July 11, 2024

RE: Stride S3 Line Project

Under the circumstances, after a detailed analysis of ST data and documents and in consultation with our community, we are now formally proposing the following alternative design concept for BAT transit improvement through Lake Forest Park (see attached).

Map of Lake Forest Park

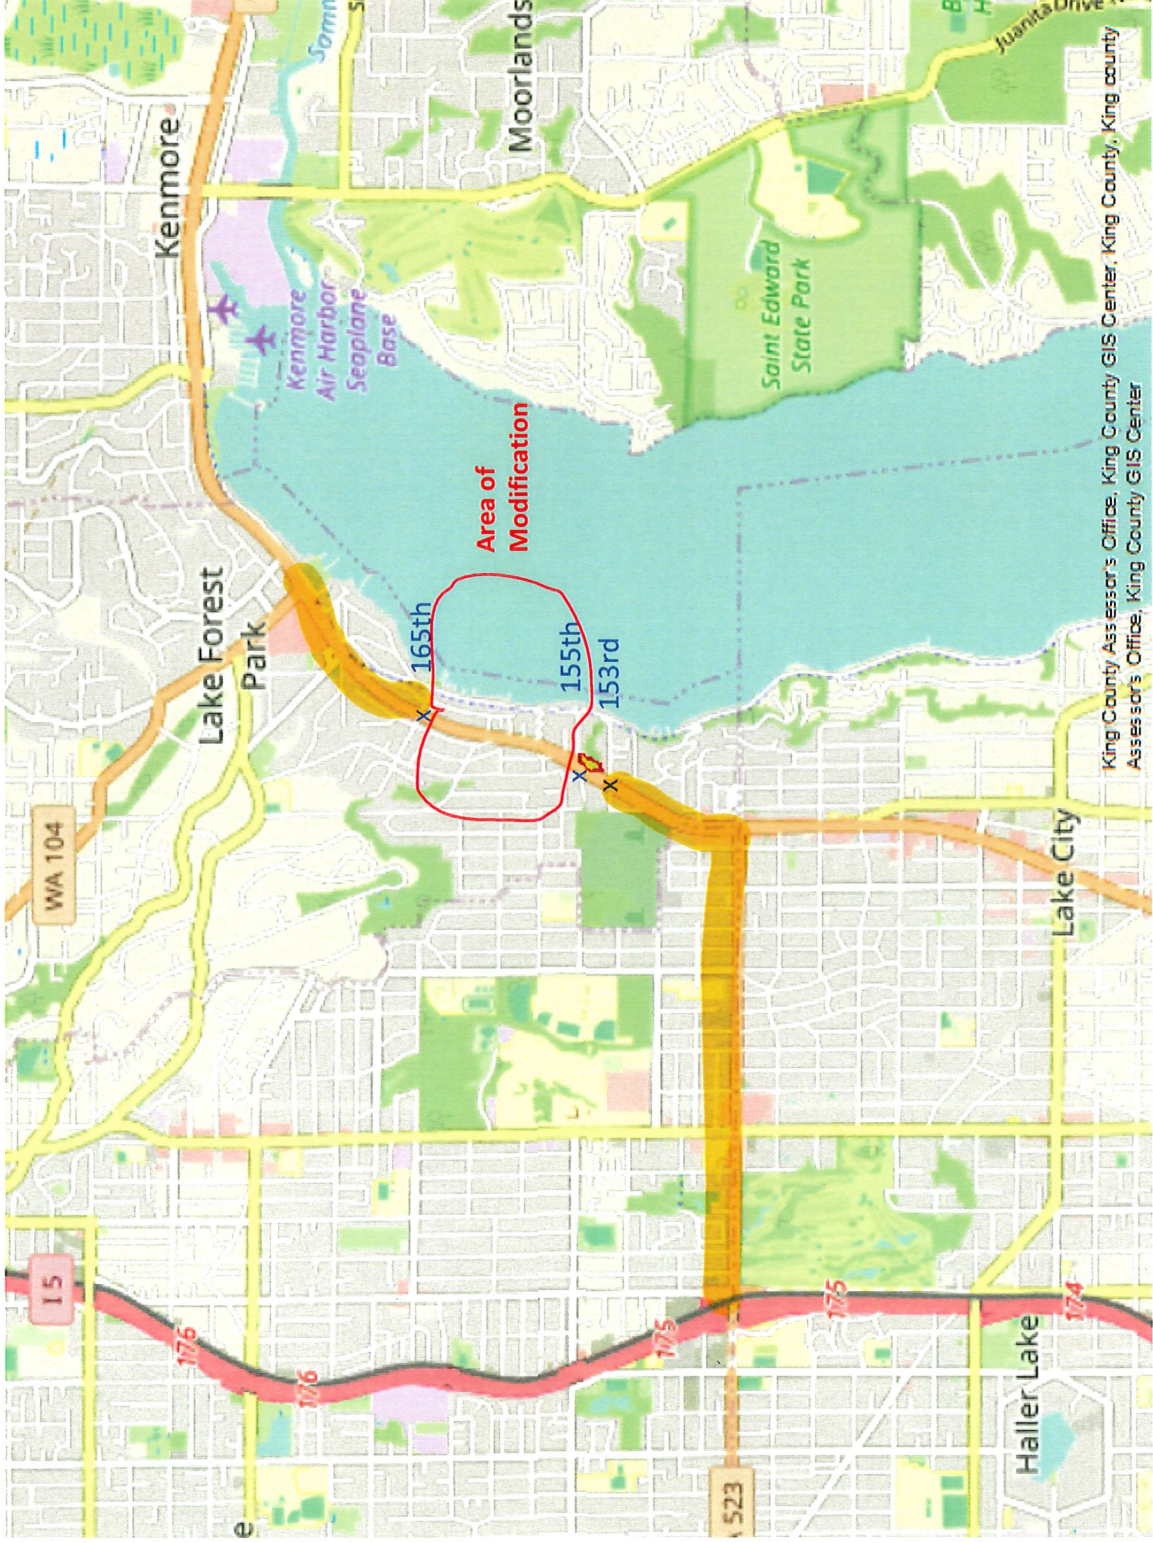
- Yellow line = SR522 Route
- Red = Bsche'tla Creek and Bridge
- X- Blue equals boundary of requested modification along route in LFP with NO WORK requested between 153rd and 155th due to liquification soil issues.

Jump Queue

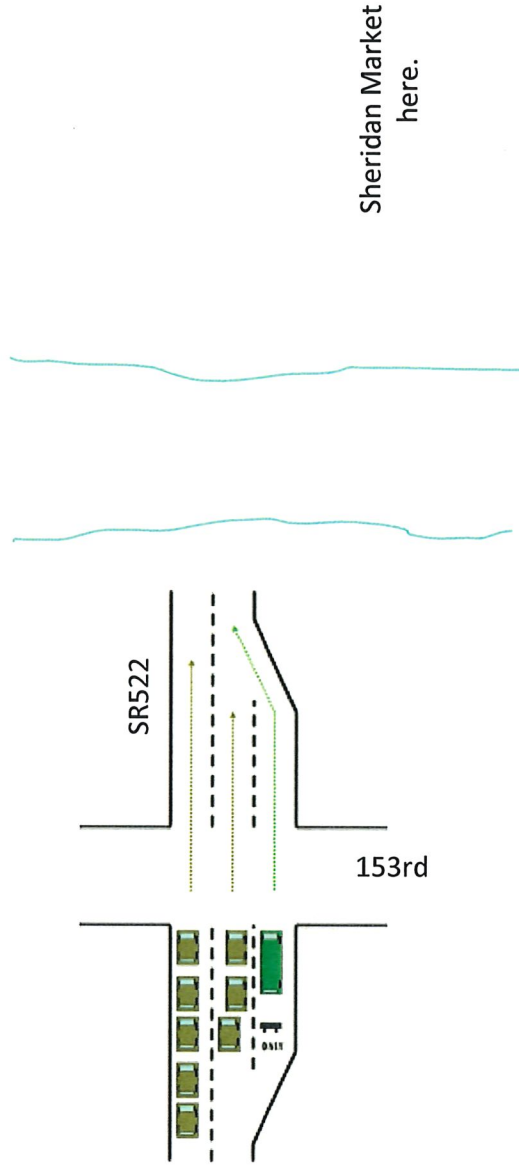
1. The image shows a 'Jump Queue' with a signalized traffic light. to be installed at 153rd.
2. This allows the bus to proceed ahead of traffic for the 10 blocks of the requested modification area. This is the SAME method that is being utilized on the ST3 project from I-5 to SR522.
3. At 165th, the route will resume as originally designed.

DRAWING No.:
BT320-CMP205
 FACILITY ID:
BT320
 SHEET No.:
0733
 REV:

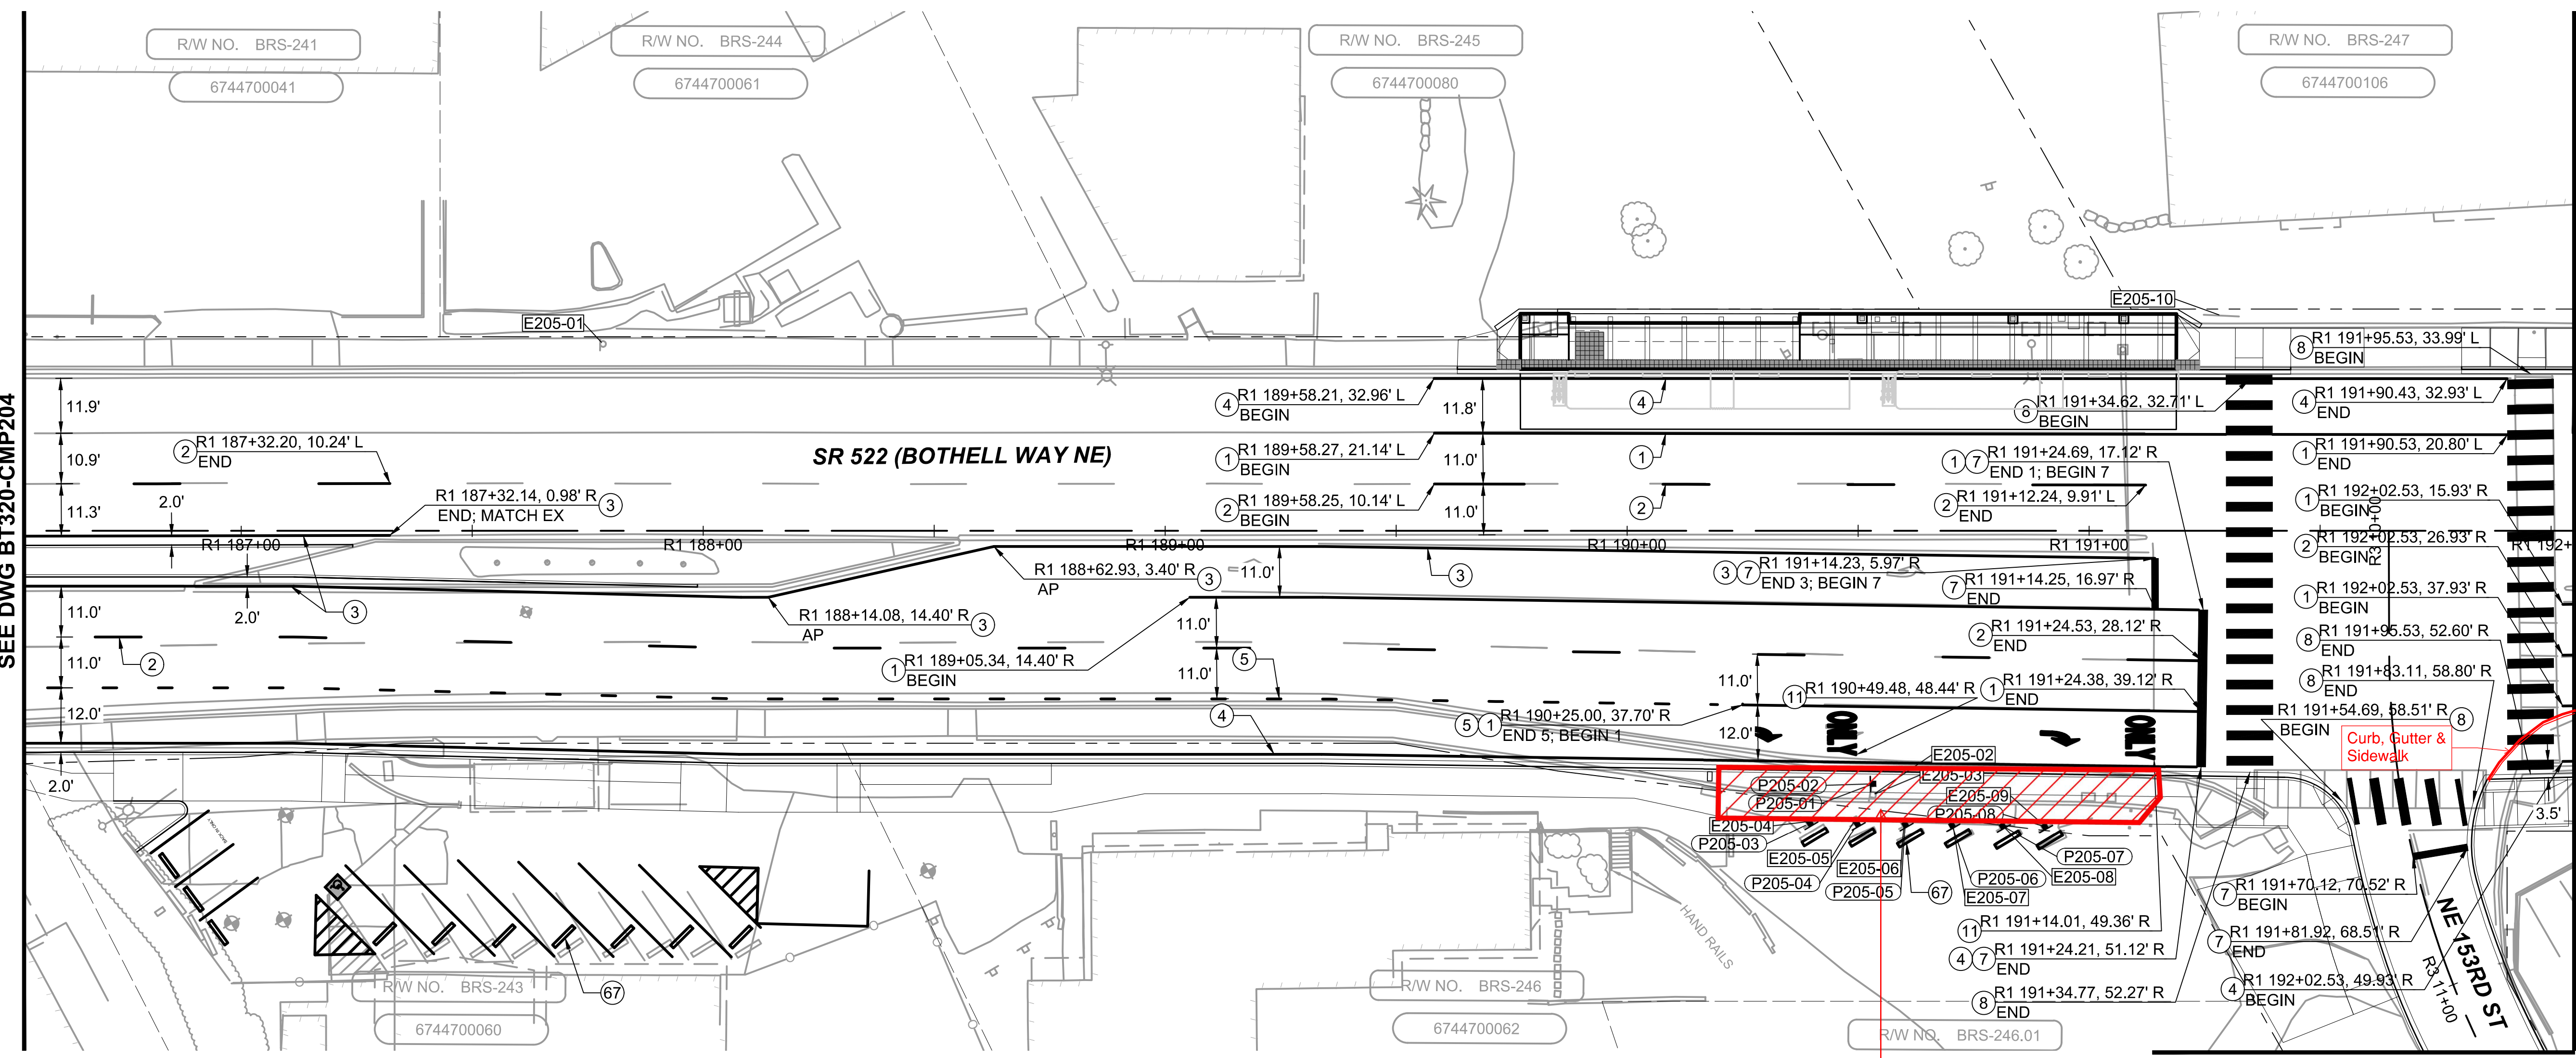
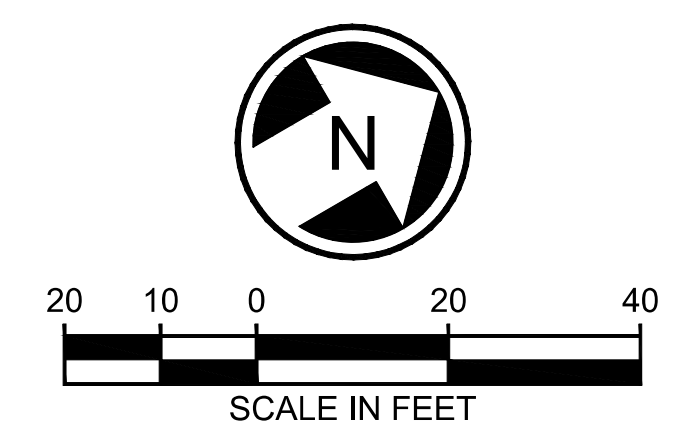
Suggested Modifications

1. Relocate bus stop prior to intersection to improve traffic flow with removed BAT lane.
2. Revise right turn lane signal to right arrows to allow for transit queue jump.
3. Revise roadway, curb, and sidewalk geometry to remove BAT lane north of NE 153rd St intersection

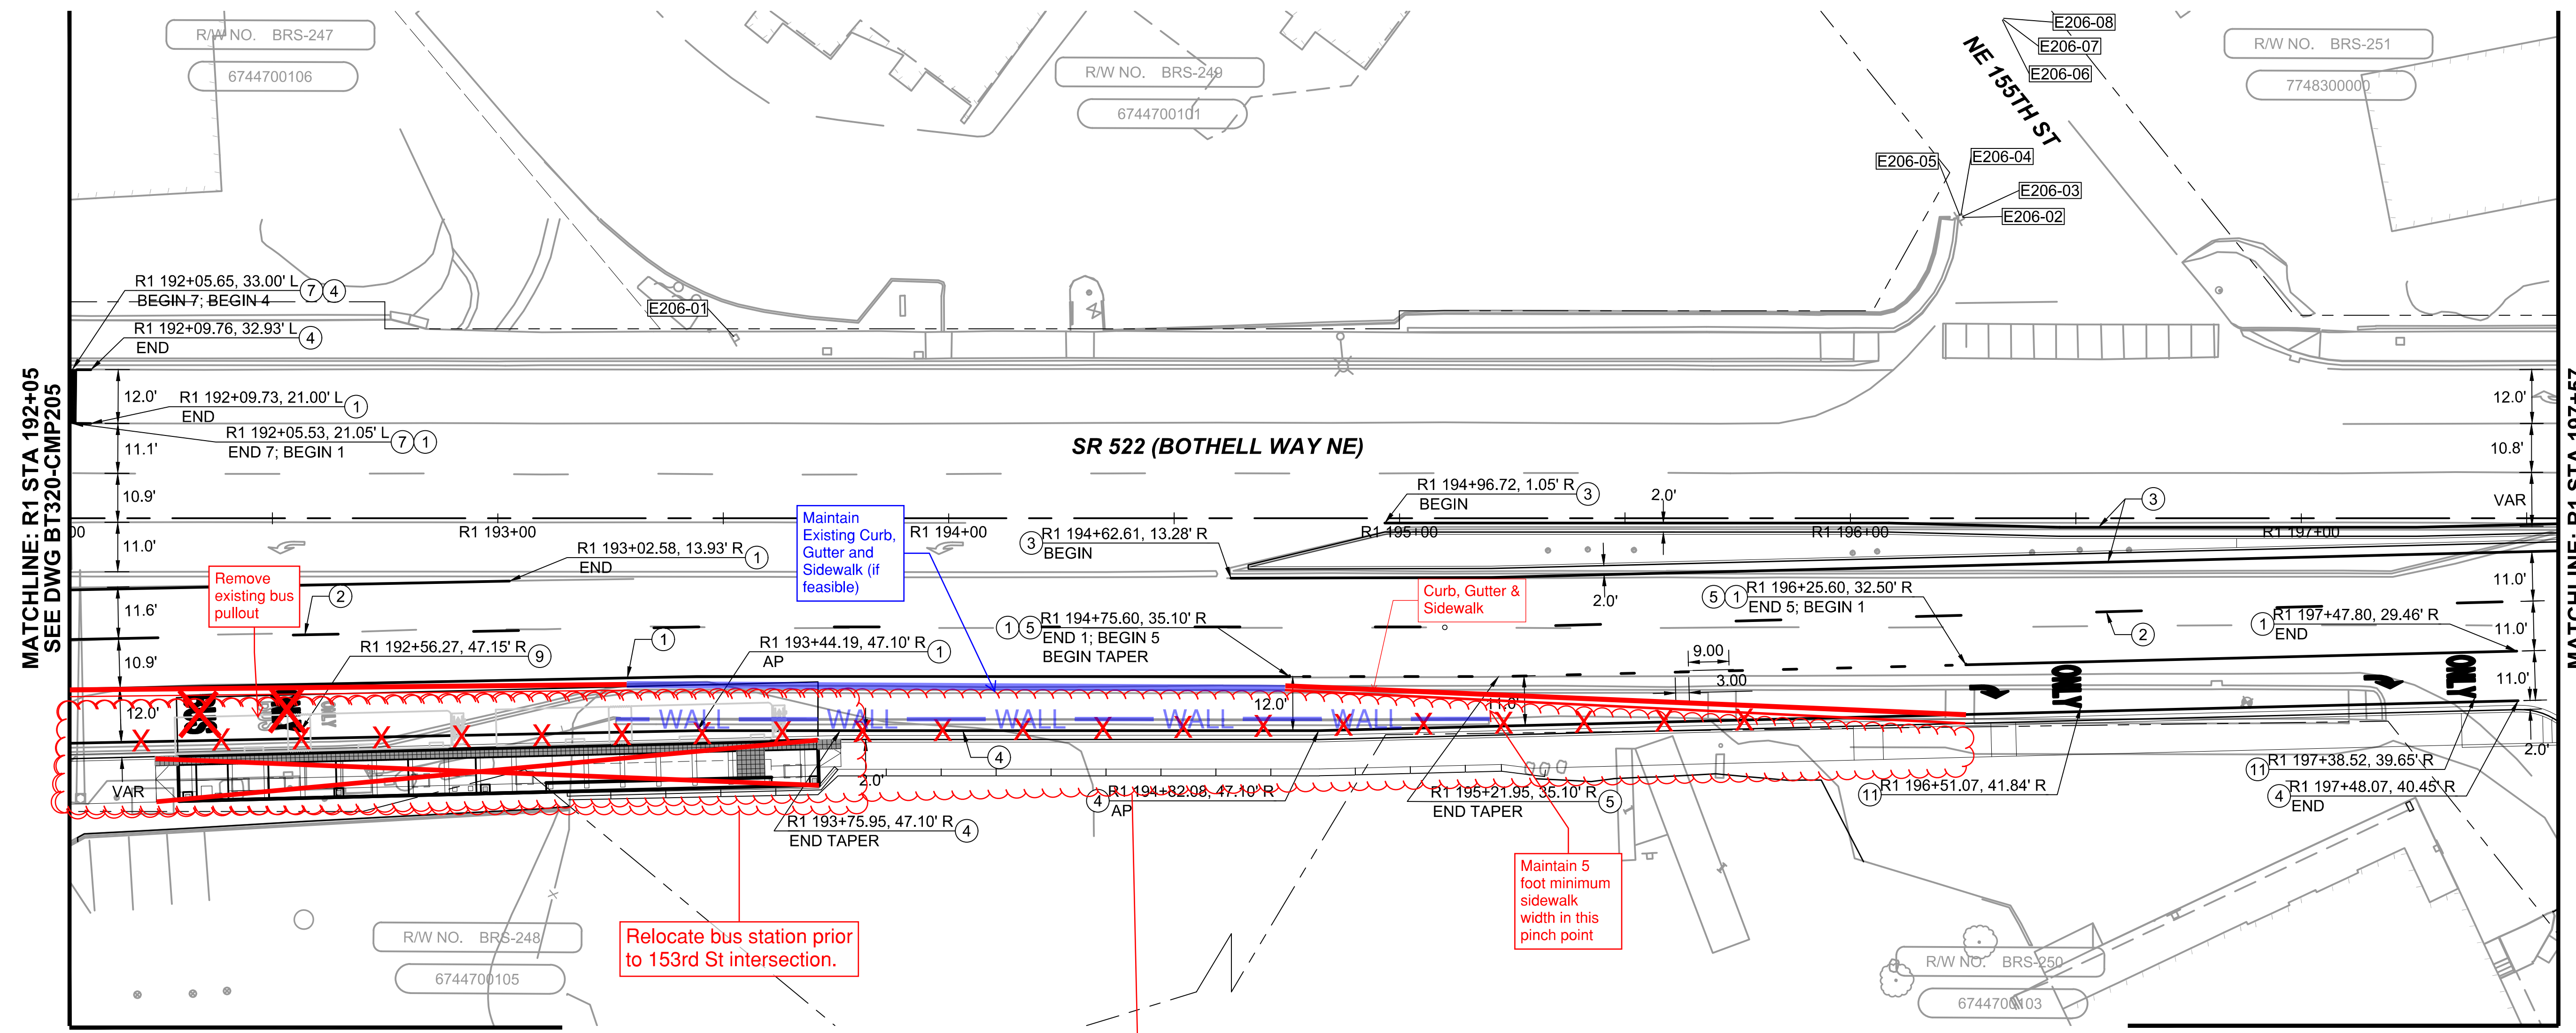
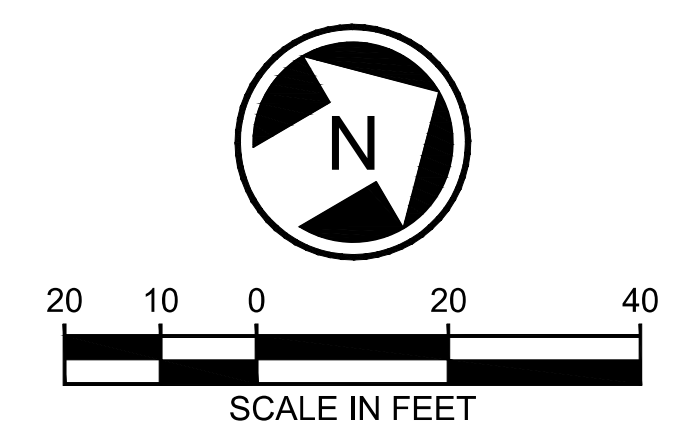
Shift sidewalk, curb, and edge of pavement improvements up to parallel proposed edge line. Maintain existing back of walk across creek with minor modifications only as necessary to complete pedestrian connections.

Suggested Modifications

1. Relocate bus stop prior to intersection.
2. Revise roadway, curb, and sidewalk geometry to remove BAT lane while maintaining right turn lane to reduce ROW impacts.
3. Revise sidewalk width to match existing creek crossing structural wall at the back of walk.
